MEGQUIER & JONES INC.
 STRUCTURAL STEEL SINCE 1895
 1156 BROADWAY
 SOUTH PORTLAND, MAINE 04106

PAIN	HOLES U N	WELD U N	QC REVIEW
PROJECT	TH NO. 1 OVER THE GIHON RIVER PROJECT NO. BHO 1448 (29) BRIDGE NO. 5 TOWN OF JOHNSON, VERMONT		DATE 6-4-09
DESCRIPTION	CAMBER DIAGRAMS		CHK'D BY GJC
ARCH	N/A	ENGR VERMONT AGENCY OF TRANSPORTATION	JOB NO J-81
CUSTOMER	S.D. IRELAND CONCRETE CONSTRUCTION CORP.		SHT NO 1

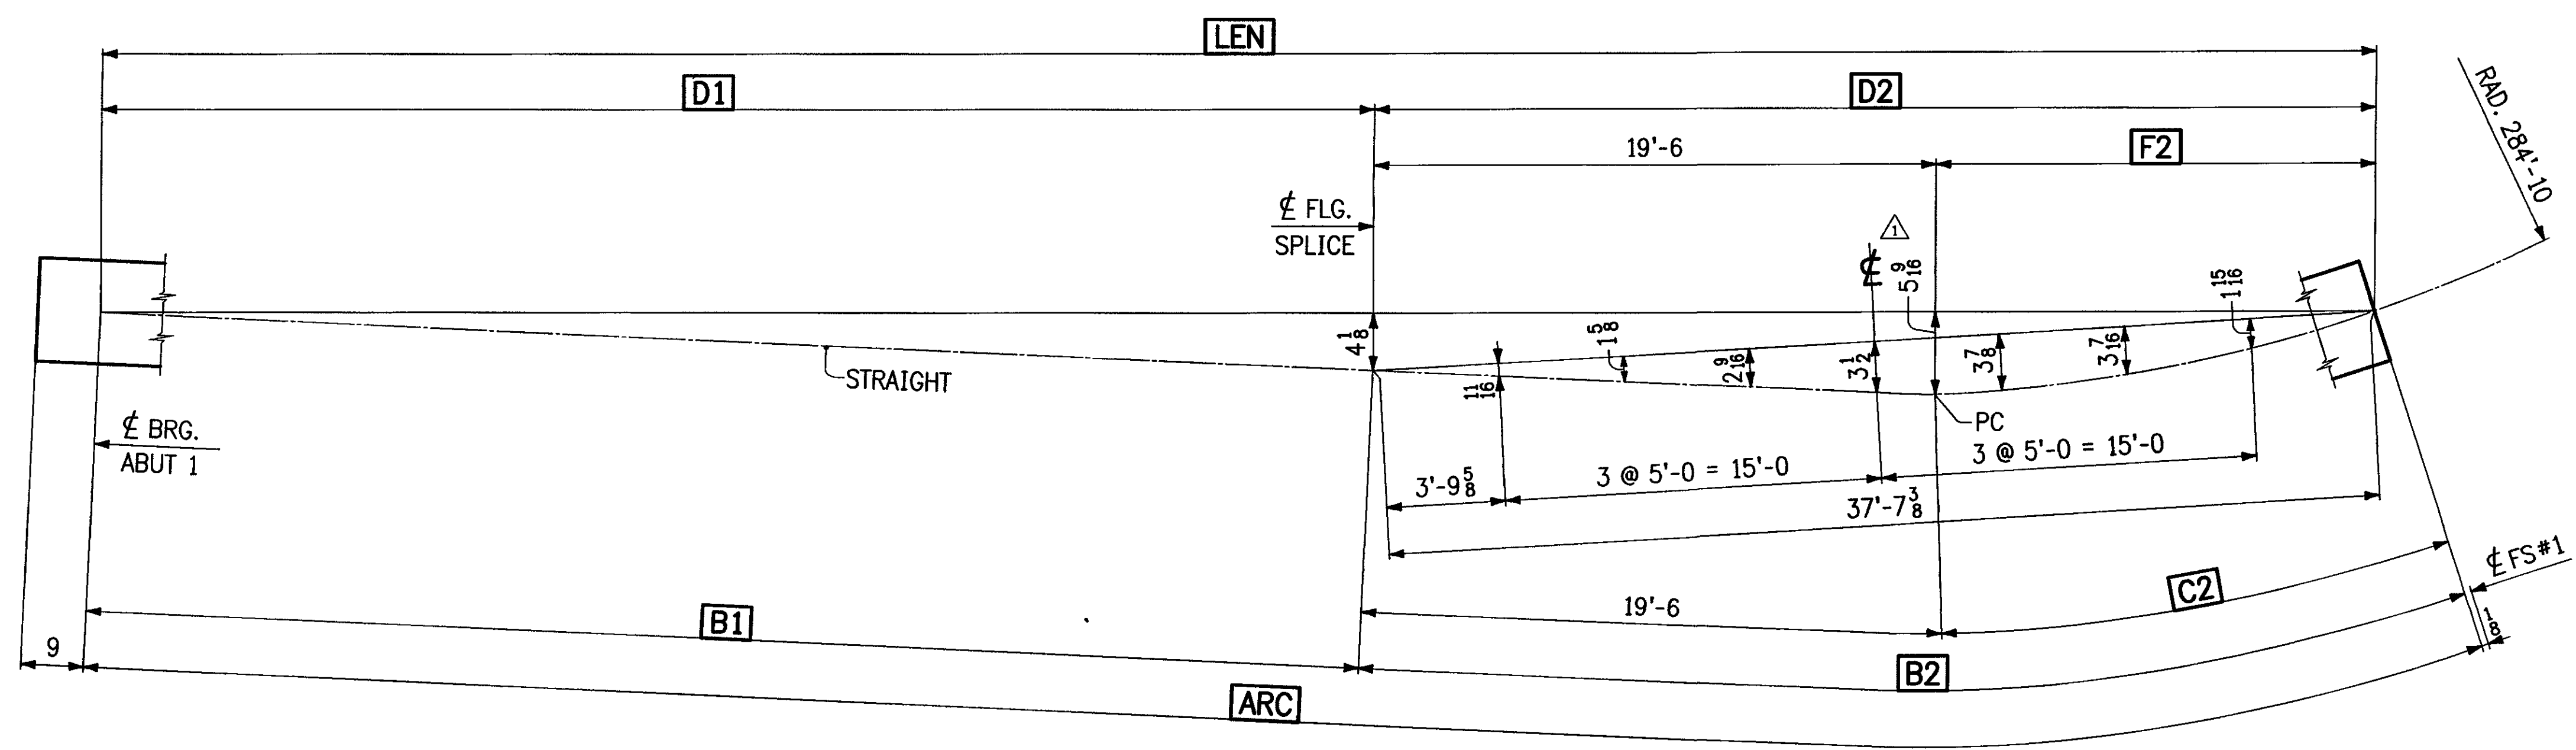
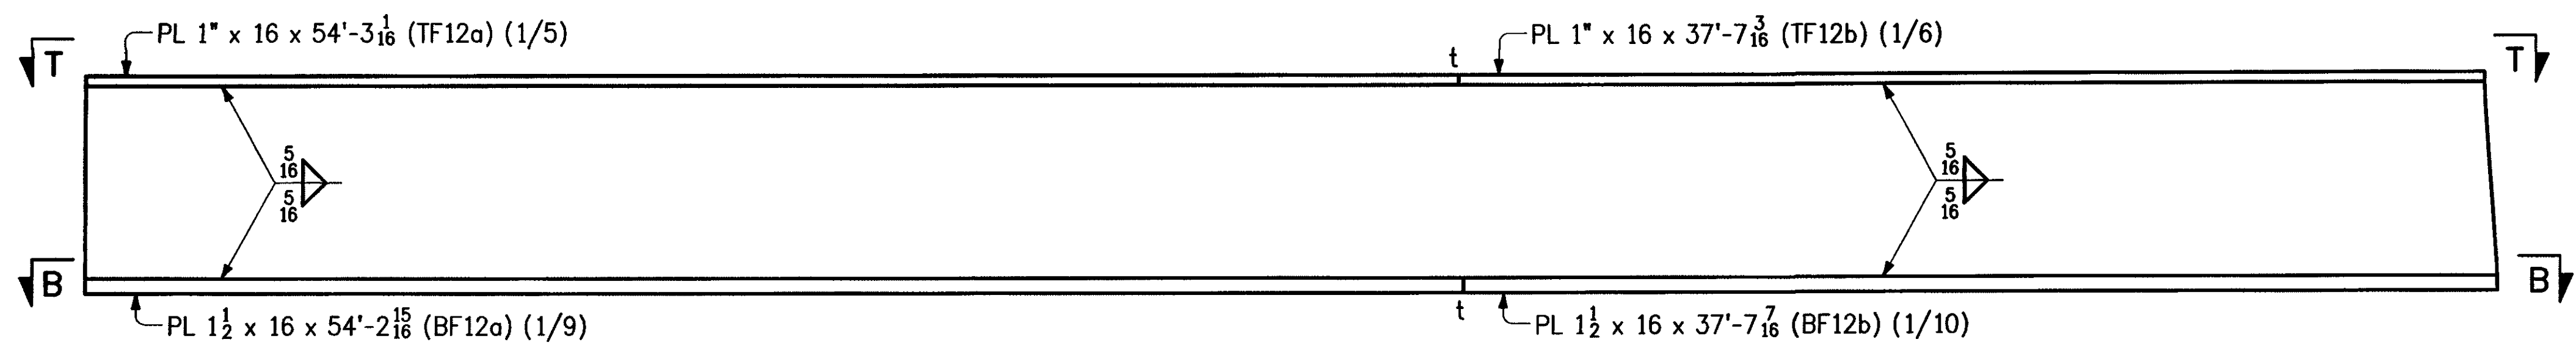
RECEIVED
 OK'D BY JEL OK'D BY LHM
 JUL 23 2009
 R.C. LHM APPROVED ✓
 BY LHM DATE 7/21/09
